SERVICE BULLETIN

Technical Service Bulletin: 51-0692

Furnace Limit Switch Service Bulletin

Model	Serial Number Range
All Small & Medium Furnaces (AFS, AFM, DFS, DFM)	73985322 – 81099541

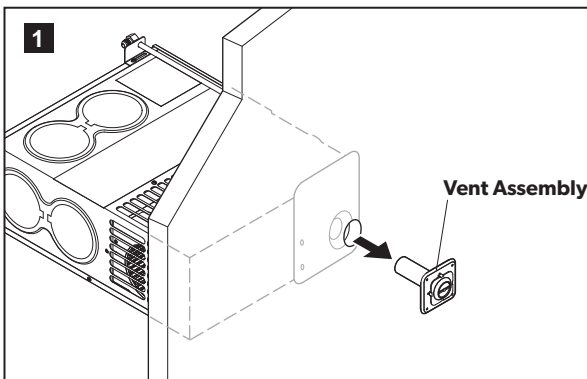
We have been able to identify a non-safety related nuisance issue that is occurring on our Dometic/Atwood furnaces. This nuisance issue has the potential to occur on all models of Dometic/Atwood Furnace with serial numbers between 73985322 and 81099541. The nuisance issue enunciates by either blowing the protective fuse, opening the circuit breaker in the furnace circuit, or rendering the furnace inoperative. Our testing has shown that in ALL instances the furnace fails in a safe manner.

The cause of this nuisance issue is a mistaken omission of a plastic wire tie to suspend the heat exchanger limit switch wires up and away from the exhaust tube vent terminal. The omission of this component allows the limit switch wires to potentially melt on the vent terminal, shorting to ground, and causing either the fuse or circuit breaker in the circuit to blow, or the sail switch to become inoperative. **In ALL cases the safety devices in the system are performing as designed and prevent the furnace from operating.**

Dometic recognizes this nuisance tripping issue is an inconvenience to our OE and potential end-use customers and we apologize for the extra work that may result. In an effort to try and reduce the amount of work required to correct this mistake we have designed and tested a field repair for this occurrence which will be more expensive for Dometic but will make the field repair much easier. The repair will consist of sliding a 6" long, high-temperature rated, fiberglass sleeve over the exhaust tube after removal of the vent assembly. The field repair kit will be available within March, 2018. The field repair kit part # is 31389, Flat Rate Time is .5 and the fault code is 617.25.

1 SLEEVING THE EXHAUST TUBE

1.1 Removing the vent assembly

1.2 Installing the fiberglass sleeve
